Commission of Architectural Review SUBMISSION APPLICATION

LOCATION OF WORK: 1914 East Franklin Street (E. Franklin & 20th Street) DATE: 19 DEC 2014

Resubmittal For Conceptual Review Only

Application No. 14-132 (Valley West LLC)

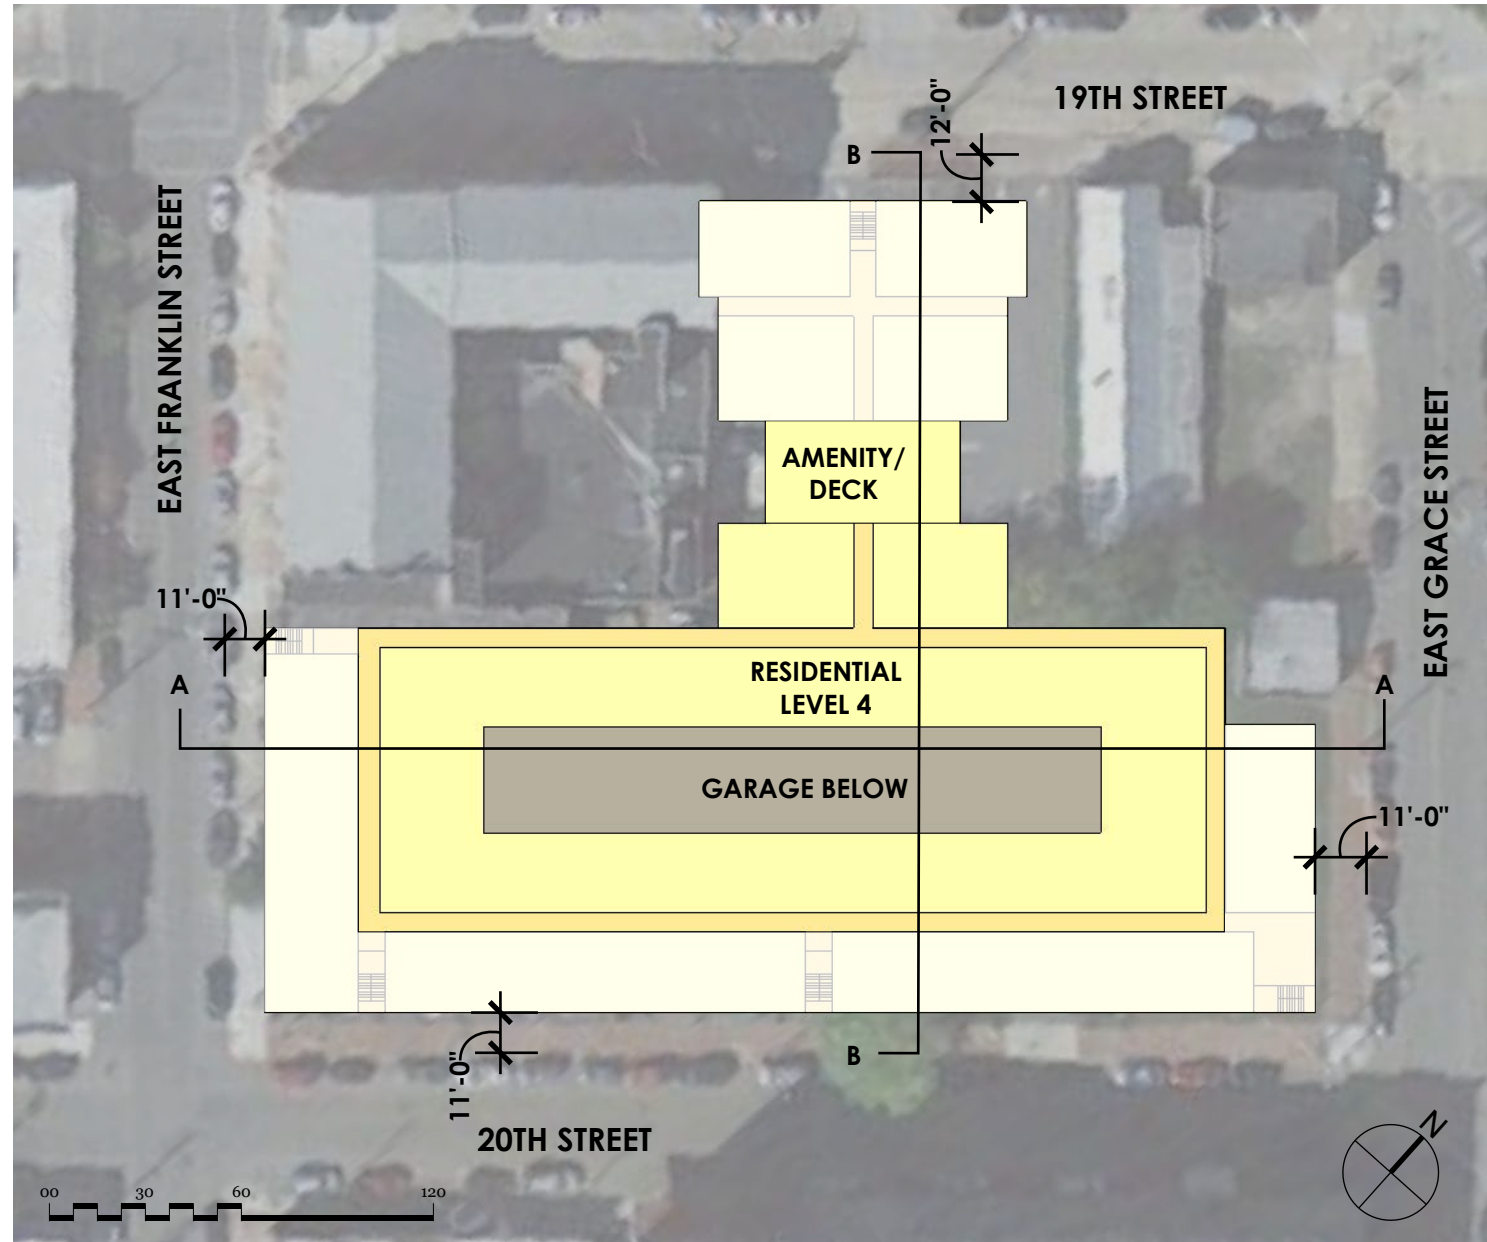
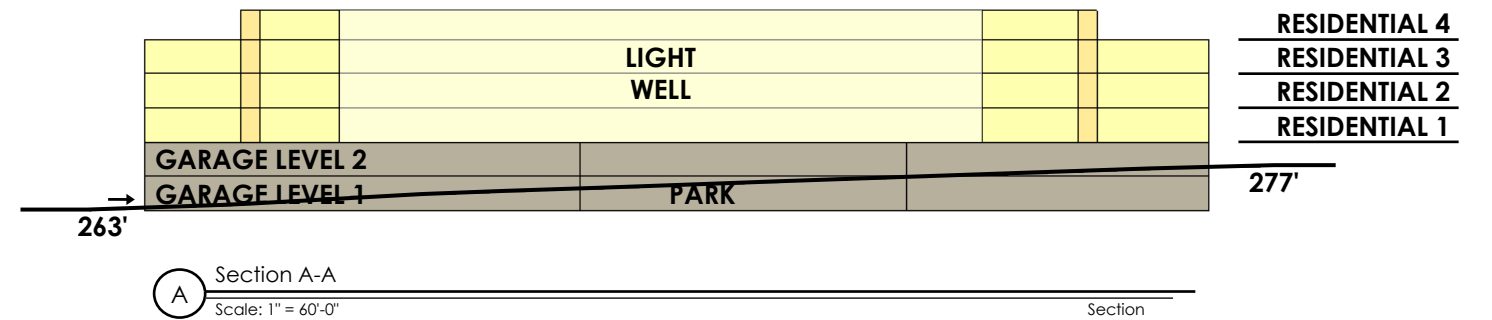
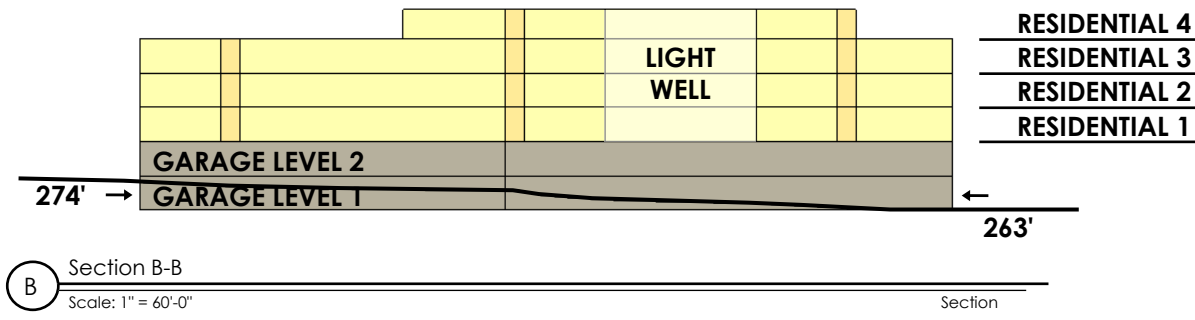
The Commission members encouraged the applicant to look at other large buildings in the neighborhood.

RESPONSE: A visual survey of the existing Shockoe Valley District was conducted and details of neighboring large industrial buildings were studied. Some of these details were
